1 Redline Revision Dated February 15, 2011

MD 117 (W.DIAMOND AVE) AND I-270 SOUTHBOUND RAMP

HAZARD IDENTIFICATION BEACON

TS NO. 4774 | DRAWING NO. 1 OF 2 | SHEET NO. OF

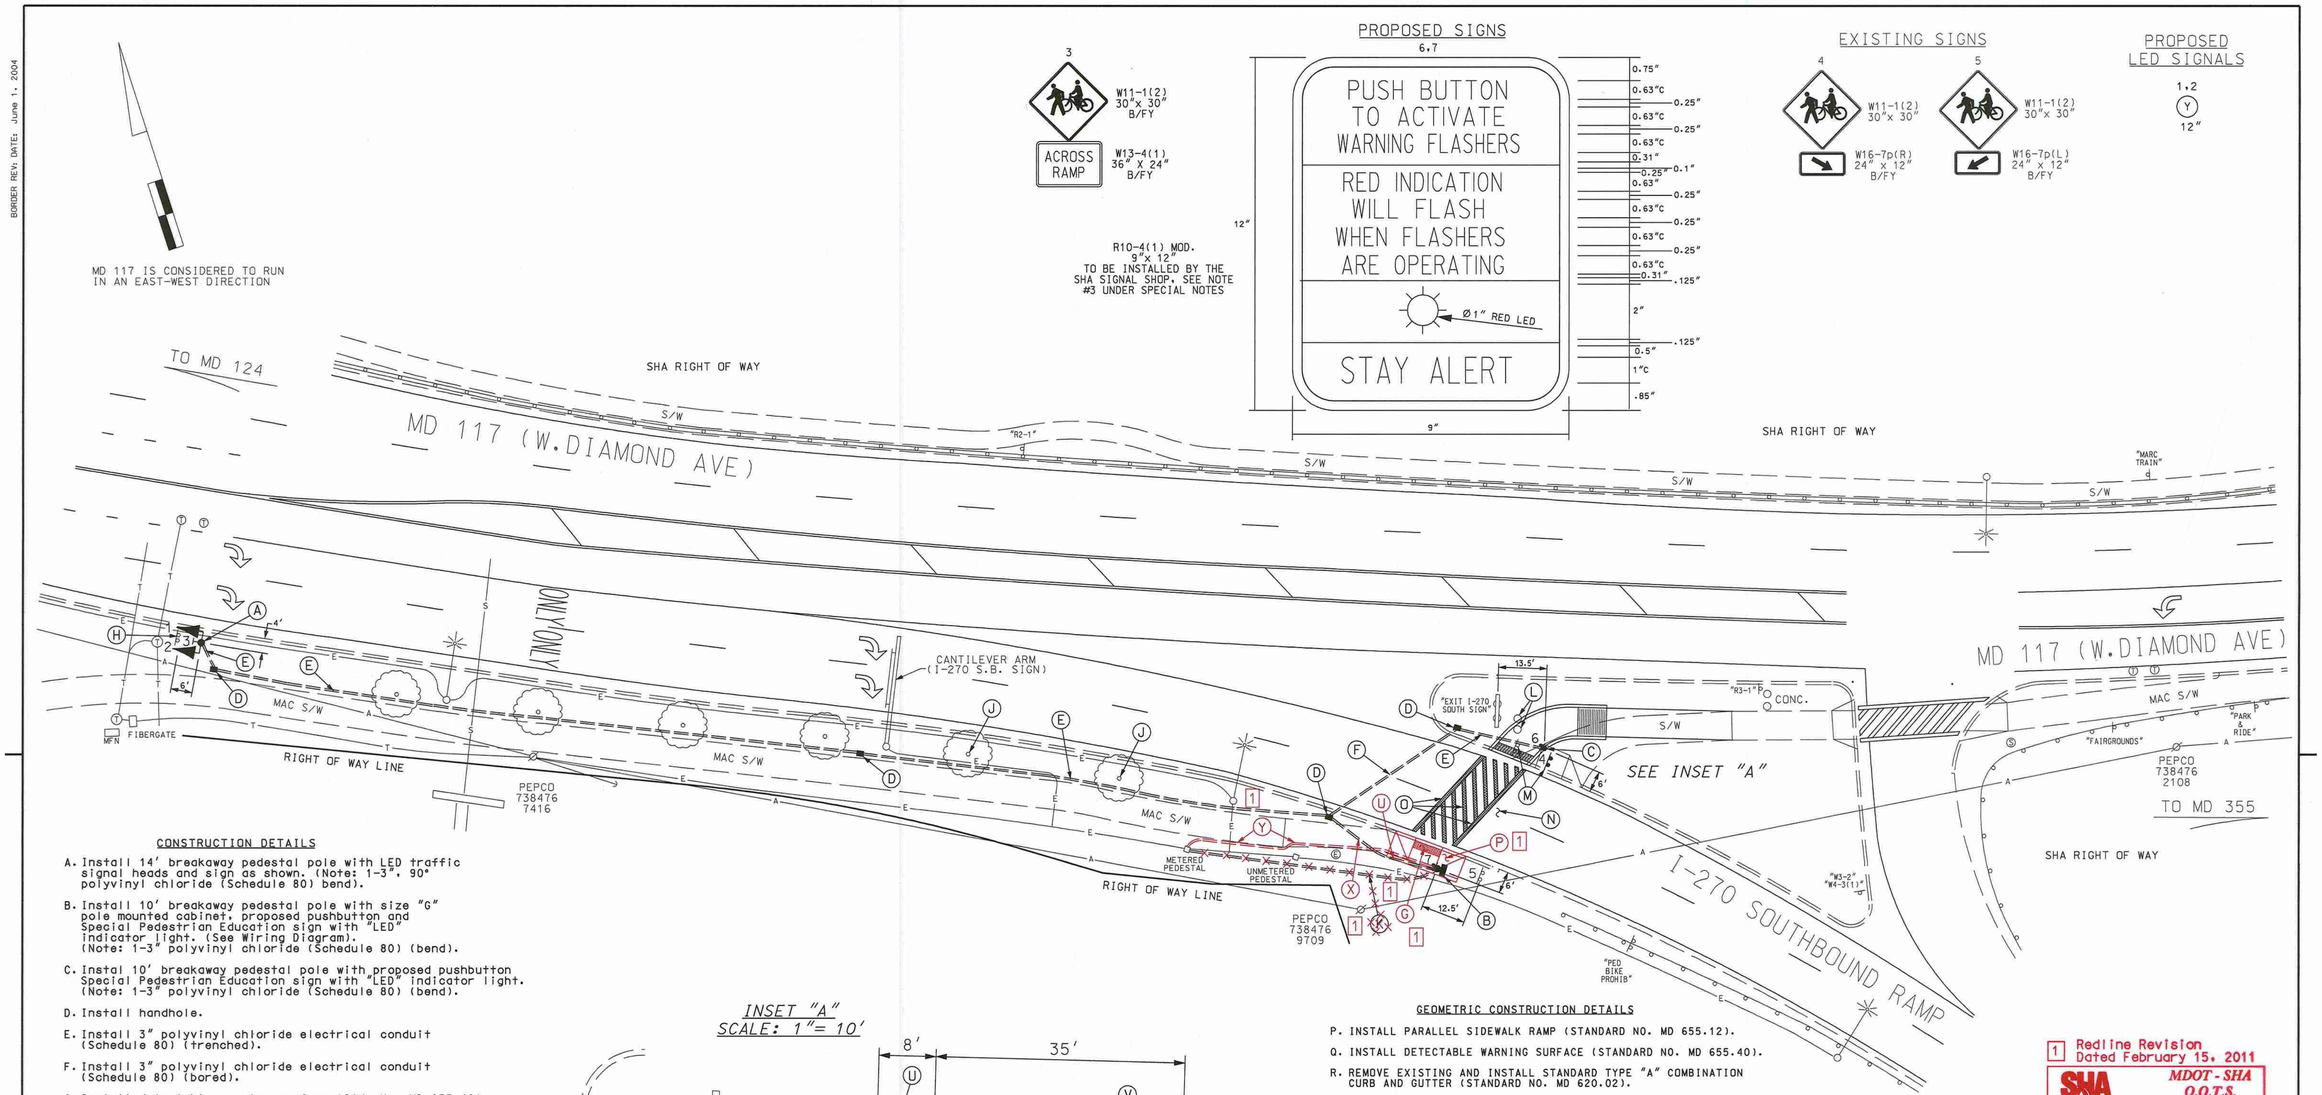
1 ~~K. Install 3" polyvinyl chloride electrical conduit (Schedule 80) (trenched) (for power service). Use existng metered pedestal.~~

1 X. Remove existing sidewalk and install 3" polyvinyl chloride electrical conduit and (Schedule 80) (trenched).

1 Y. Remove existing necessary sidewalk to install 3" polyvinyl chloride electrical conduit (Schedule 80) (trenched) (for power service). Use existng metered pedestal.
